# MONITORING YEAR 4 ANNUAL REPORT

## OWL'S DEN MITIGATION SITE

RE: Owl's Den Mitigation Site-Year 4 Monitoring Report  
Final Submittal for DMS  
Contract Number 004673, RFP Number 16-004110, DMS# 95360  
Yadkin River Basin – CU# 03040105; Union County, NC

Wildlands Engineering, Inc. (Wildlands) has reviewed the Division of Mitigation Services (DMS) comments and observations from the Owl's Den Mitigation Site Draft Year 4 Monitoring Report. Wildlands walked the site on 1/7/2019 to evaluate the site condition after the beaver dam was removed. Wildlands confirmed that the streams are stable and that monitoring features have not impacted by the beaver dam. The report text has been revised for the final draft to reflect the most current condition of the site. The following are Wildlands responses to your comments and observations from the report noted in italics lettering.

Wetland Re-establishment

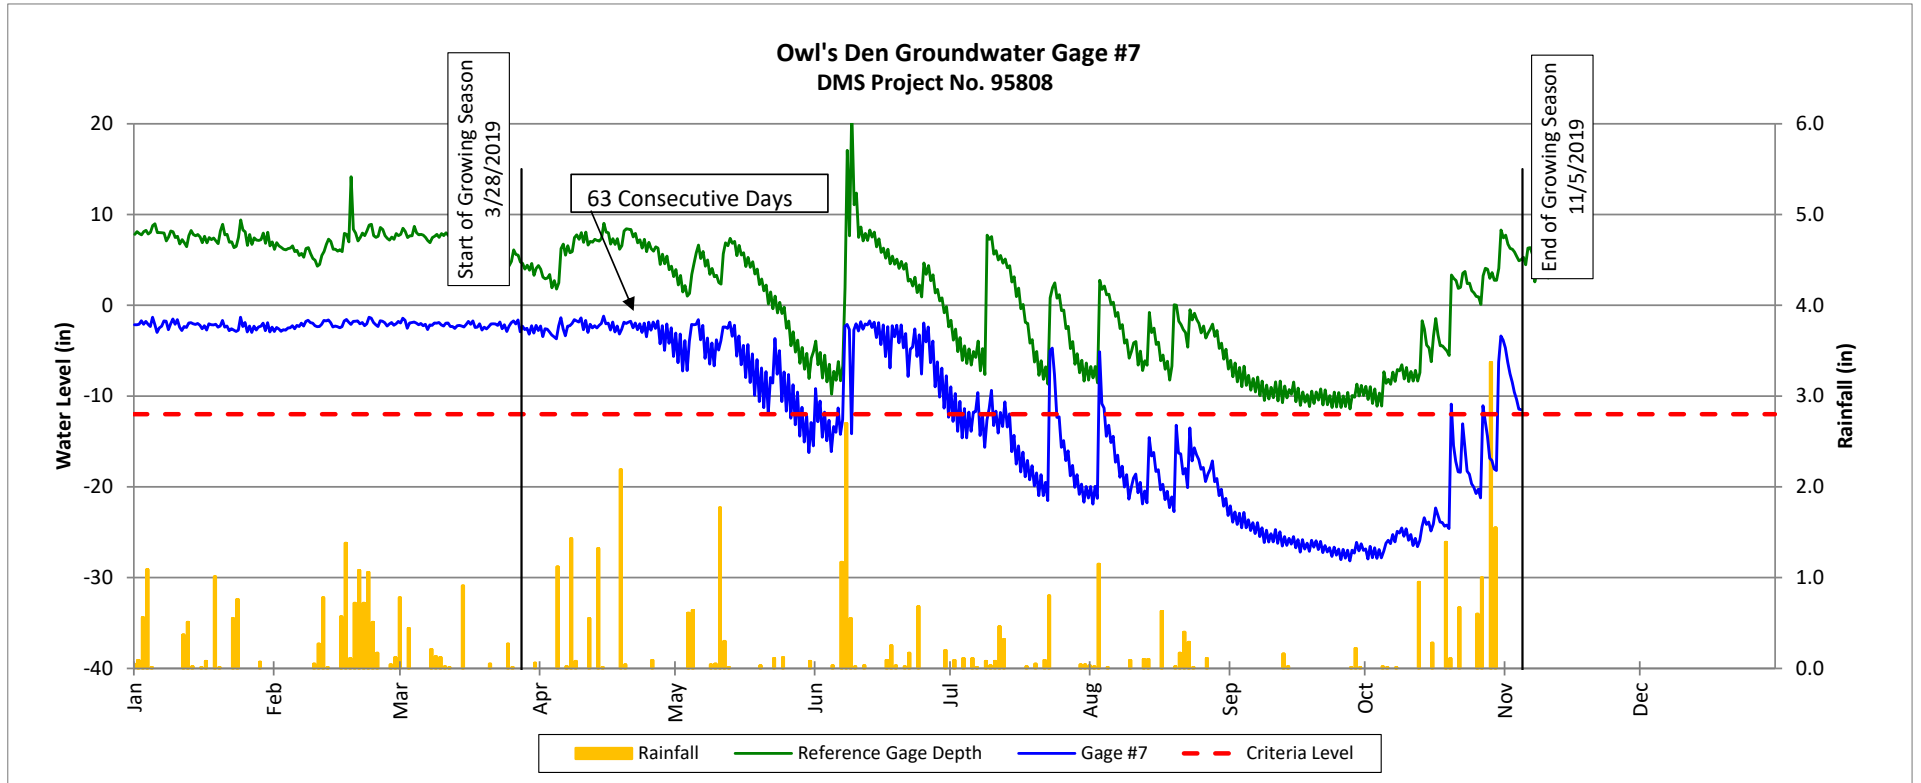
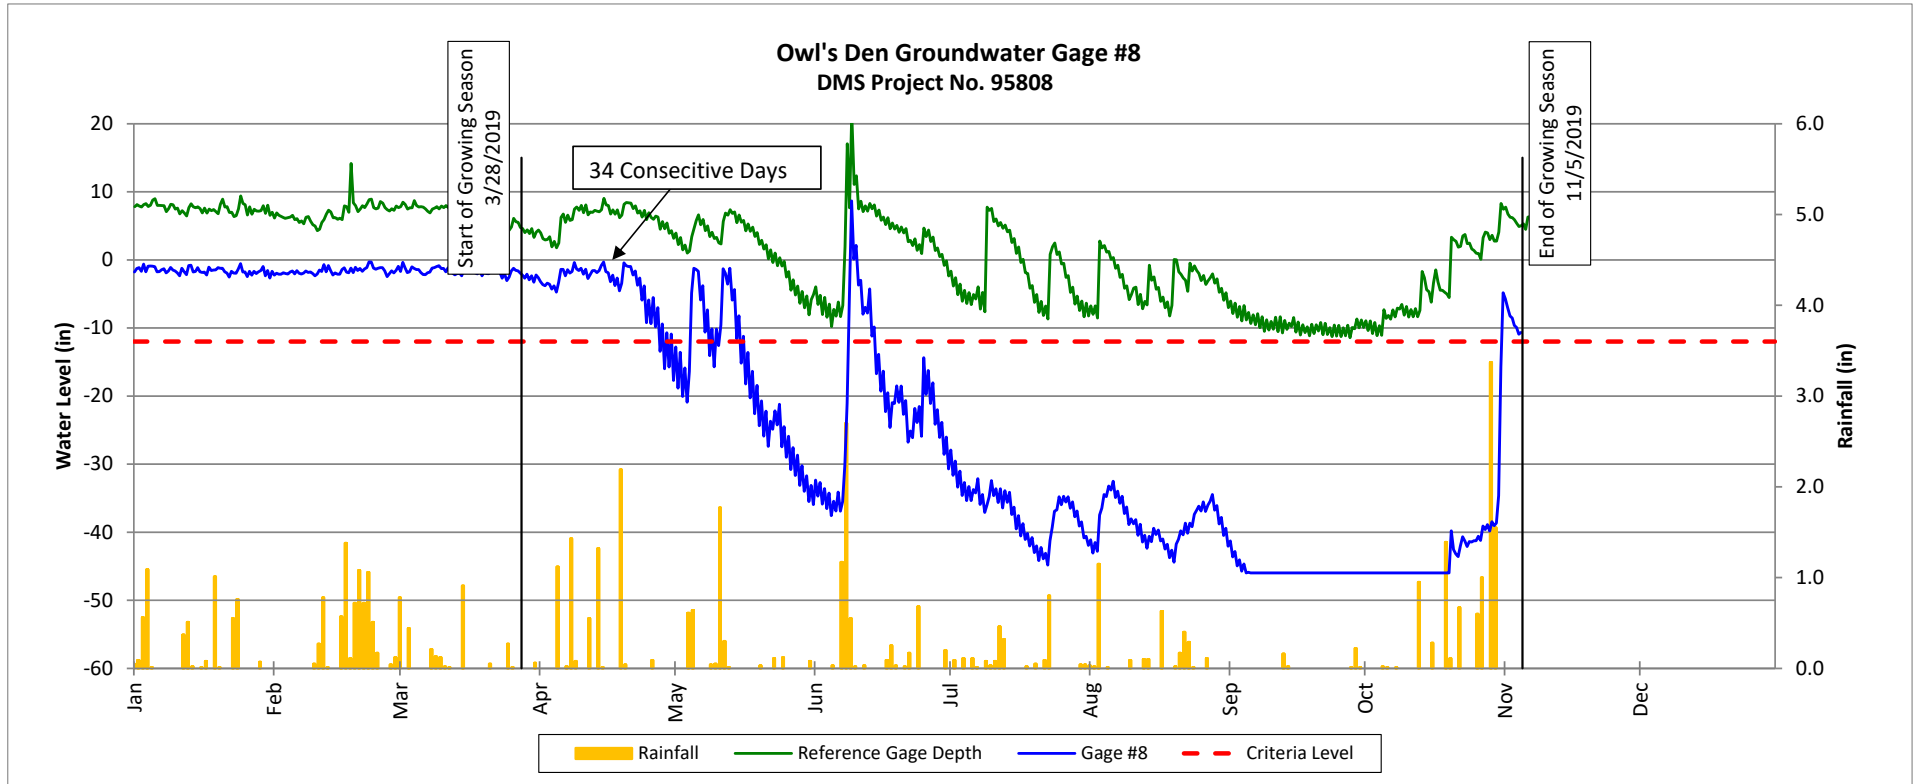
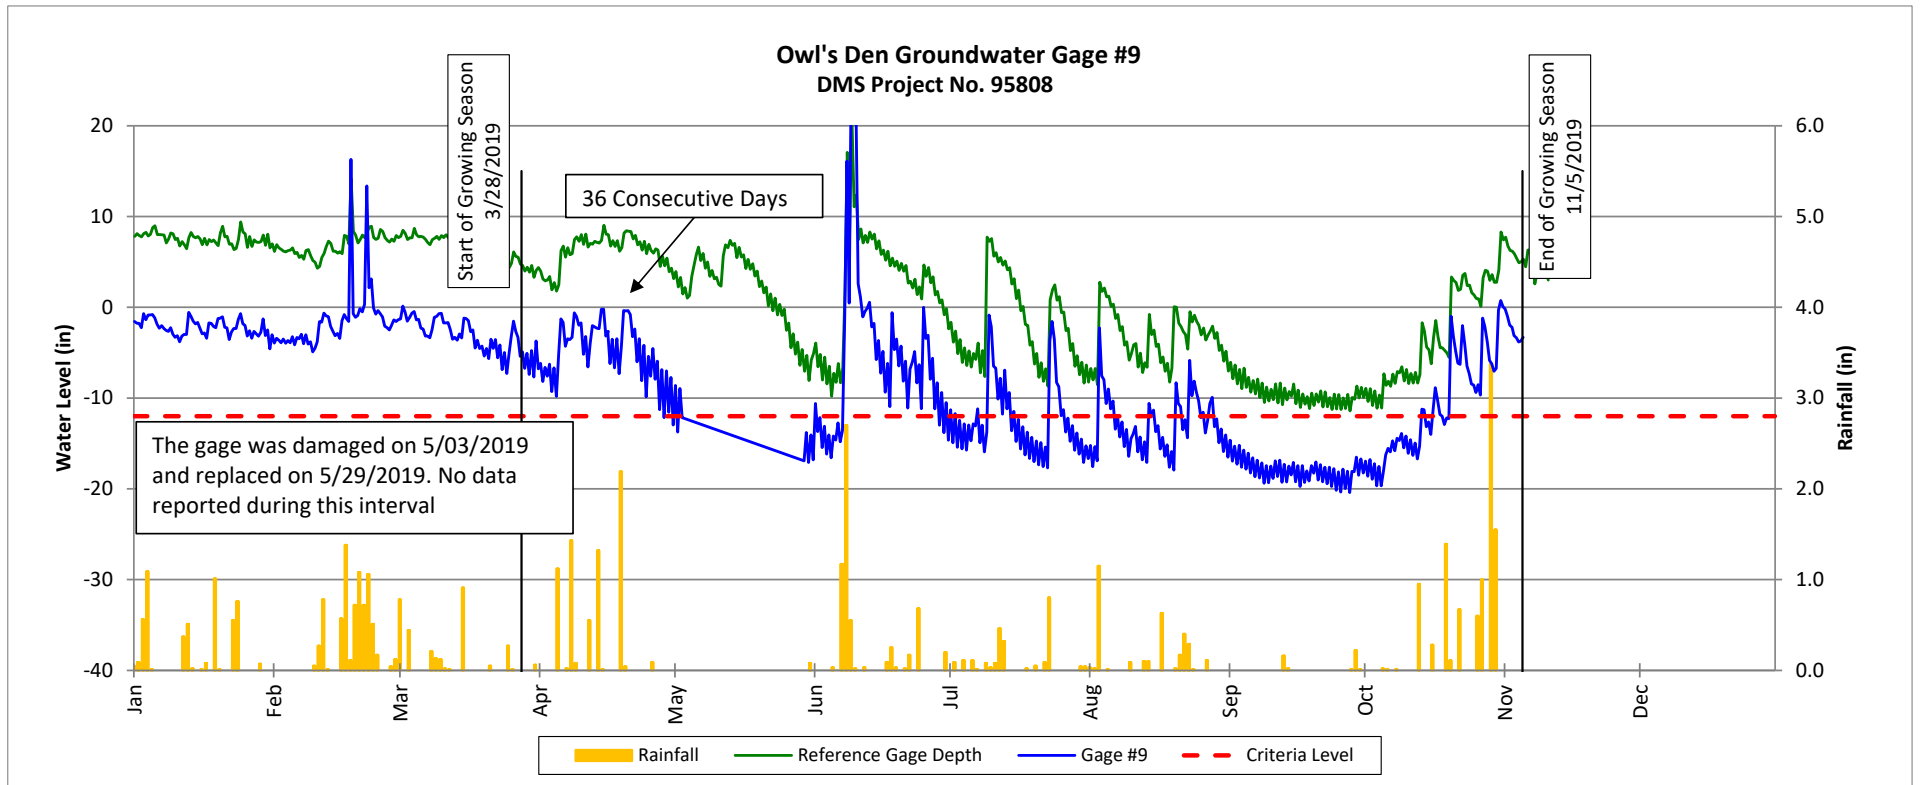
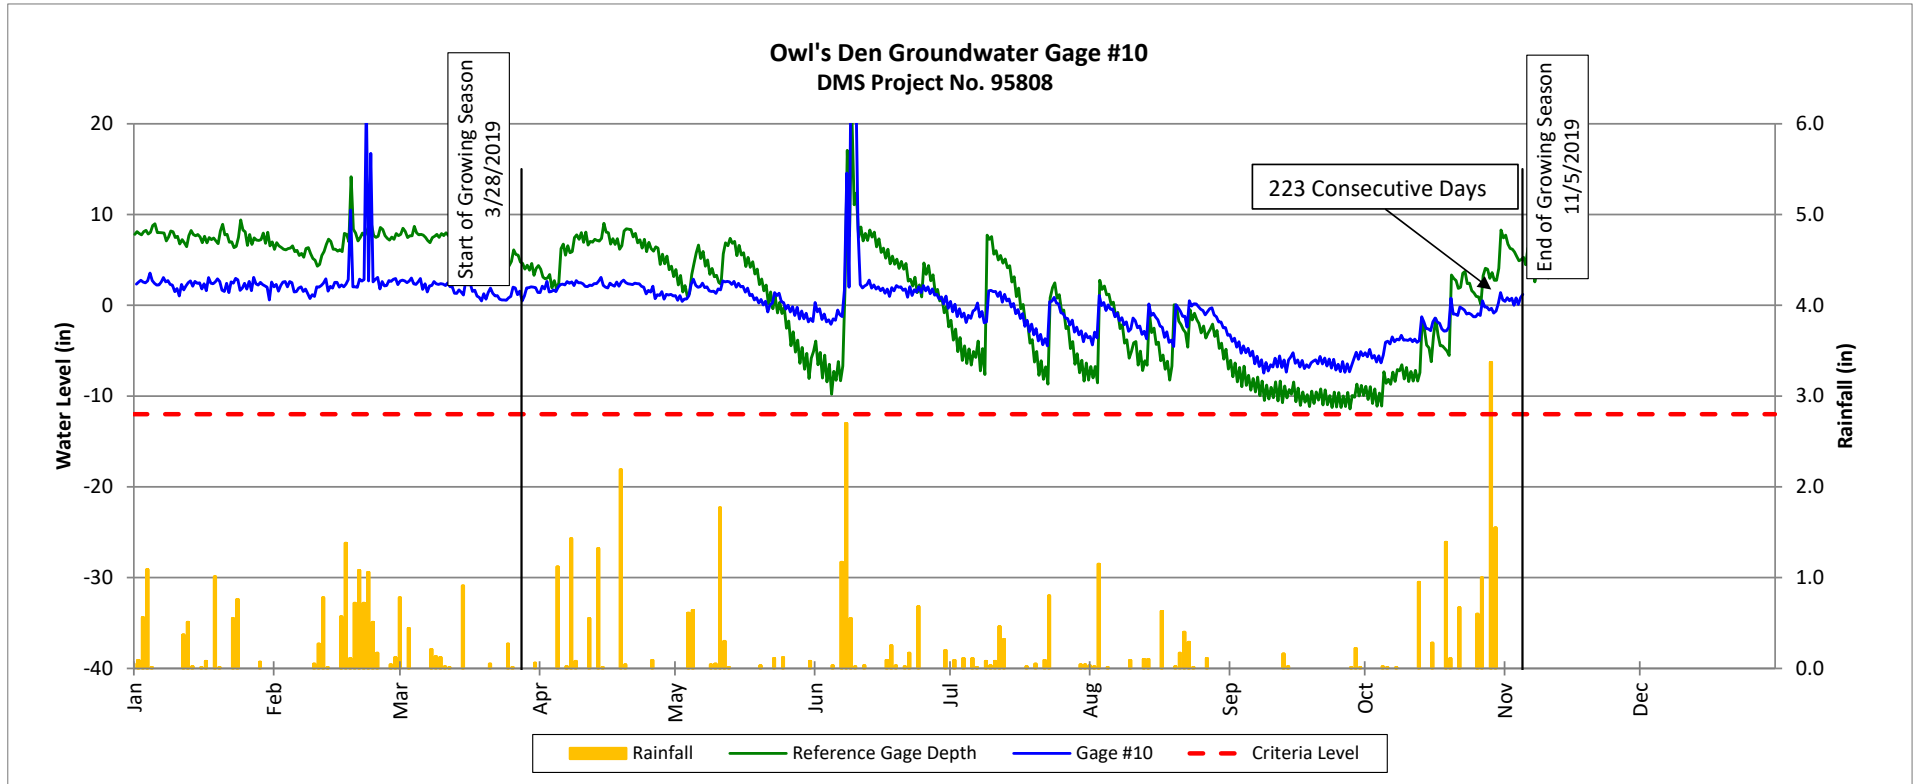
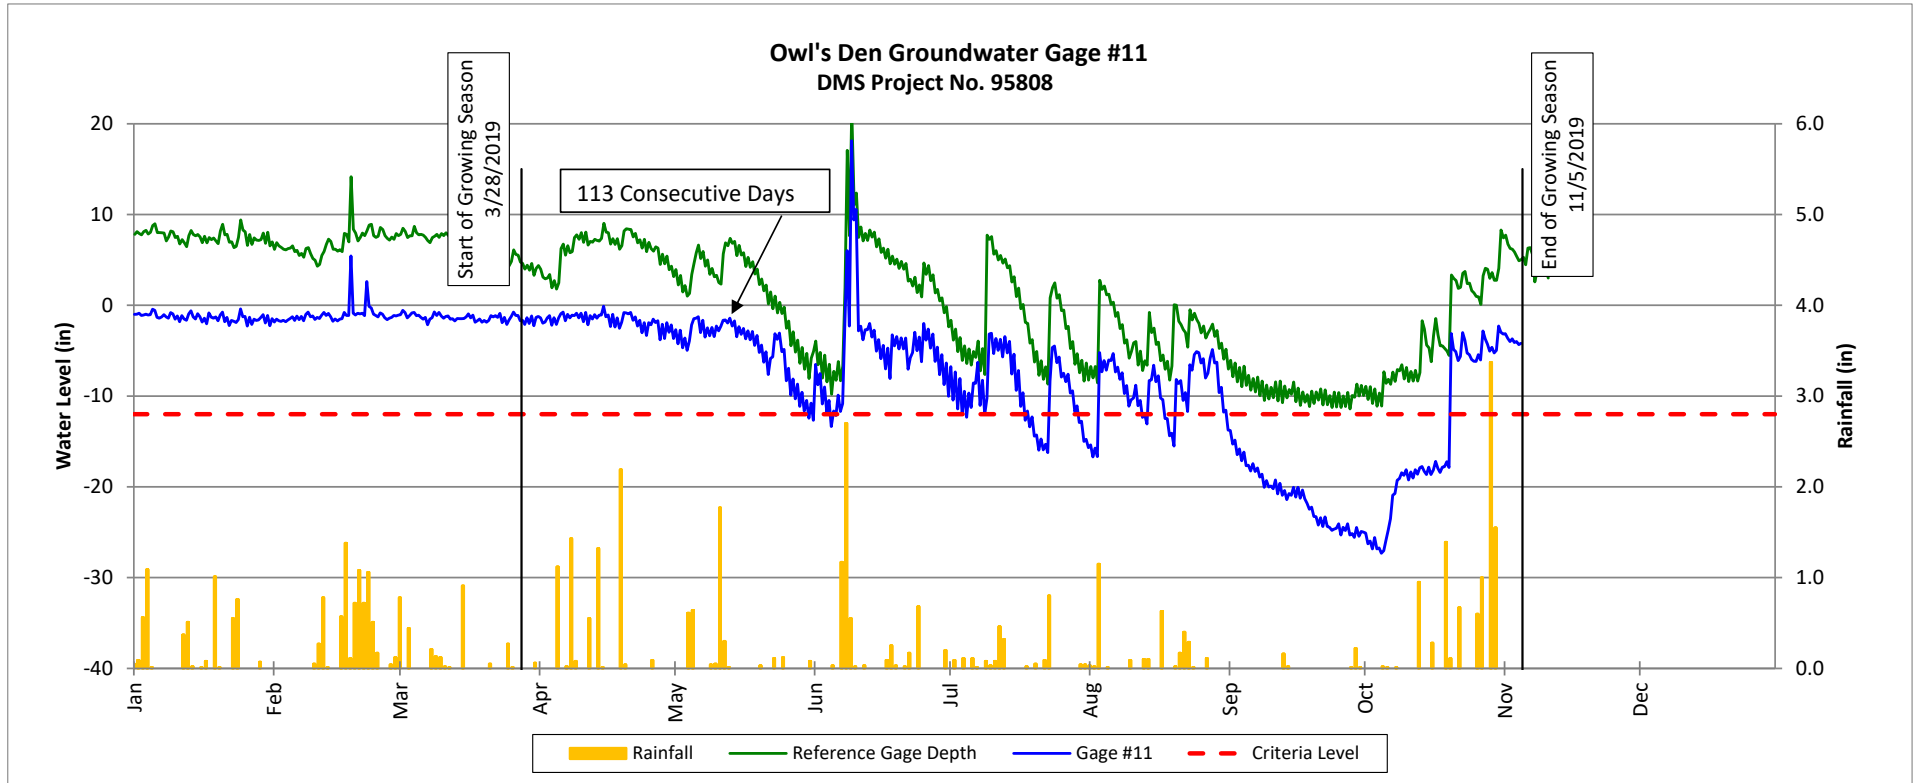
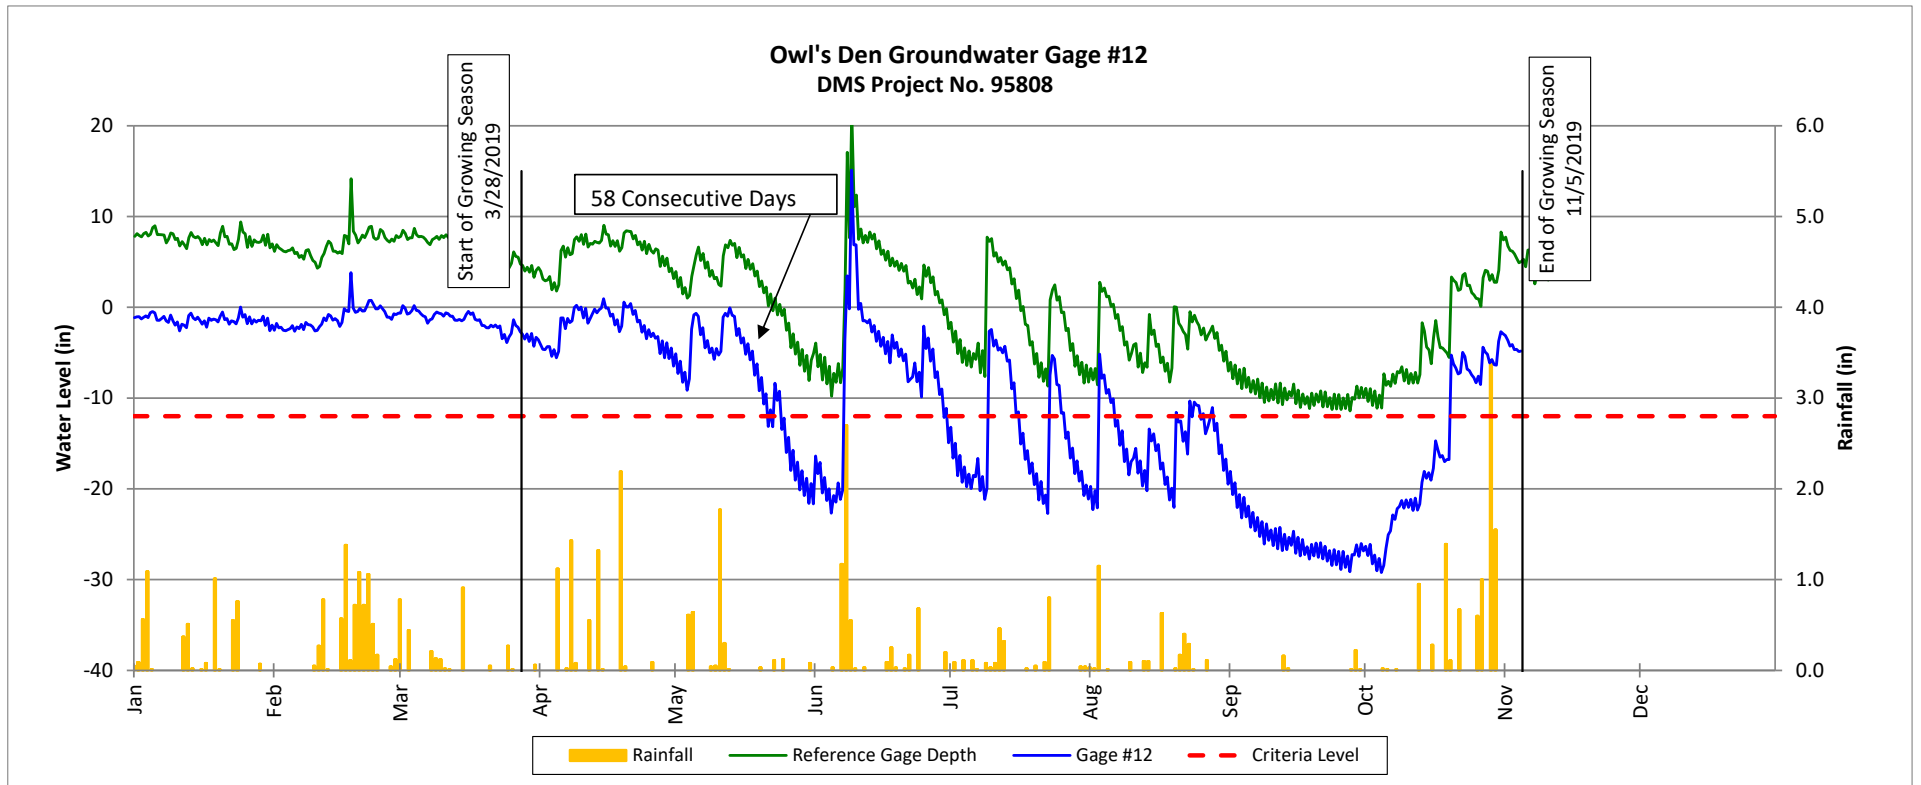
**DMS Comment; Groundwater gage plots: For clarity, consider adding the consecutive day number for each gage on the groundwater gage plots instead of using the currently shown 18-day bar. The 18-day bar adds some confusion to the plots without a description of what it corresponds to (8.1% of the growing season).**

*Wildlands Response; The consecutive number of days meeting criteria was added to each groundwater gage plot and the 18-day bar was removed.*
